City of Santa Fe, New Mexico

memo

2026-011886-HDRB. 521 Calle Corvo. Downtown and Eastside Historic District. Contributing. Rajah Bose, agent for Louis Pepper and Ruth Williamson, owners, request approval for a 348 sq. ft. addition to a height of 14'-05" where the maximum allowable height is 16'-4", window, door, and portal replacement. Exceptions are requested to 14-4.6(G)(4)(I)(a) historic windows shall be repaired or restored wherever possible, 14-4.6(G)(4)(I)(c) no new opening shall be made where one presently does not exist unless historic documentation supports its prior existence, and 14-4.6(G)(4)(II)(a) architectural features, finishes, and details other than doors and windows, shall be repaired rather than replaced.

Figure 5. Existing and Proposed South Elevation.

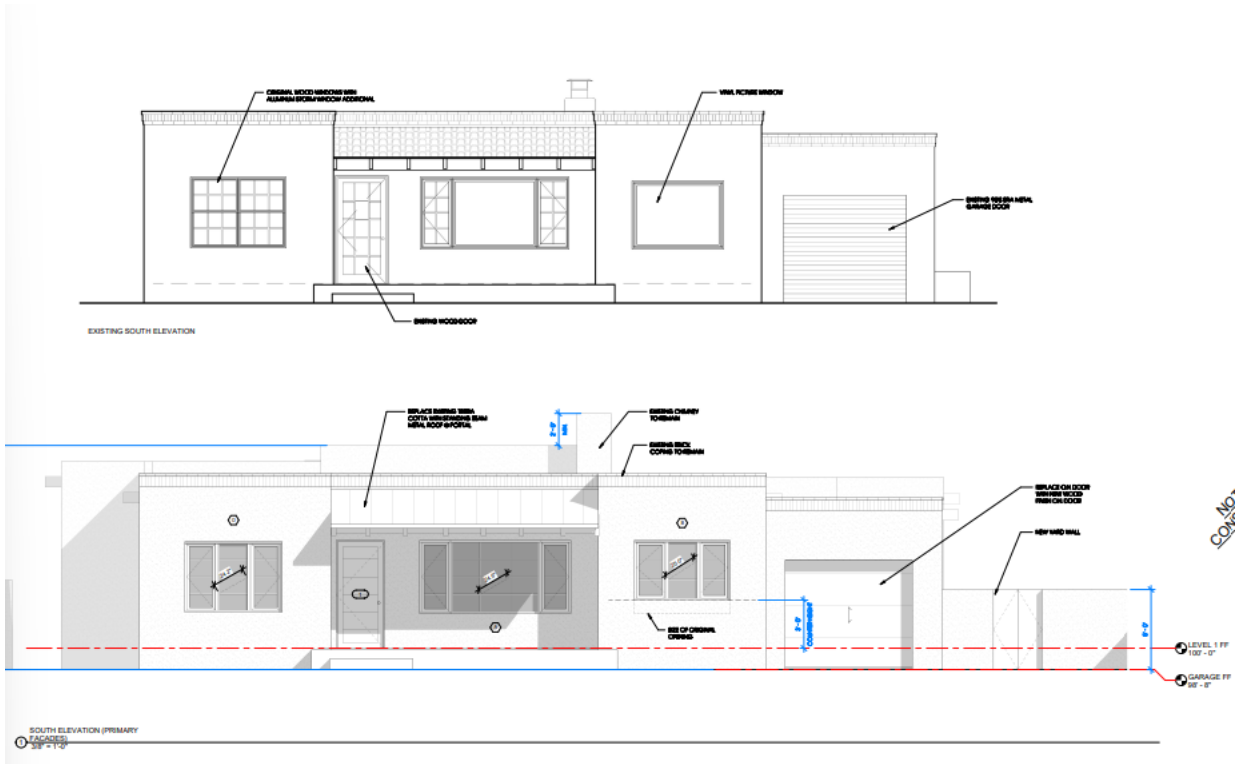
Exception to 14-4.6(G)(4)(I)(a) historic windows shall be repaired or restored wherever possible: The applicant requests an exception to replace historic windows on the south primary façade.

Applicant Response: We believe the proposed new window package not only prevents any damage to the district, but actually brings the house into better compliance with the district’s design values, most specifically relating to the divided-lite windows. You will see in our proposal elevations that the eastern most window on the south façade, window unit “C” (see elevations), was at some point replaced with a picture window.

Staff Response: Staff finds that this criterion is not met. The proposed wholesale window replacement with divided-lite windows on the south primary façade change the historic conception and give a false sense of history on this streetscape where many of the homes on Calle Corvo were constructed with picture windows.

Staff Response: Staff finds that this criterion is not met. The applicant poses a good argument, however given the current code citation which states, “historic windows shall be repaired or restored wherever possible” on the primary facades the applicant has not provided sufficient information to justify the removal of historic windows and more information is needed for the Board to determine the current condition of these historic doors and windows.

Staff Response: Staff finds that this criterion is not met. The applicant proposes another relative argument, however the applicant has not provided the Board a full range of design options to consider, rather they have

chosen to present a whole-sale window replacement with limited information on the reparability of the historic windows. Additional information is needed for the Board to make a decisive decision for the proposed window replacement.

Exception to 14-4.6(G)(4)(I)(a) no opening shall be widened or narrowed: The applicant requests an exception to narrow a historic window opening from 4' high by 4' wide to 3' high by 4' wide.

Staff Response: Staff finds that this criterion is not met. Given the Board's recent status review and primary façade designation for the subject property, the current request to narrow the picture window would adversely impact the primary façade and the streetscape and additional information is needed to assess the current condition of the historic window opening.

Staff Response: Staff finds that this criterion is not met. No hardship has been found to change the current dimensions of the picture window on the primary façade.

Staff Response: Staff finds that this criterion is not met. The applicant has not provided the Board a full range of design options to consider, additional information is needed for the Board to make a decisive decision for the proposed narrowing of the historic window opening.

Exception to 14-4.6(G)(4)(II)(a) architectural features, finishes, and details other than doors and windows, shall be repaired rather than replaced : The applicant requests an exception to replace the terra-cotta portal roof tile with a metal standing seem roof.

Staff Response: Staff finds that this criterion is not met. The defining character of the Calle Corvo streetscape is what needs to be taken into consideration and several properties have portals with the terra cotta tiling as roofing material. There are no properties along this streetscape that have metal standing seem portal roofs publicly visible on Calle Corvo.

Staff Response: Staff finds that this criterion is not met. No hardship has been found to change the roofing material from terra cotta tile to a metal standing seem roof.

Staff Response: Staff finds that this criterion is not met. The applicant has not provided a full range of roof options for the current terra cotta tile portal. A metal standing-seem roof option seems to be an extreme change

to the historic portal that currently exists. Additional information may need to be requested to clearly identify the best options for re-roofing the portal with the proper material.
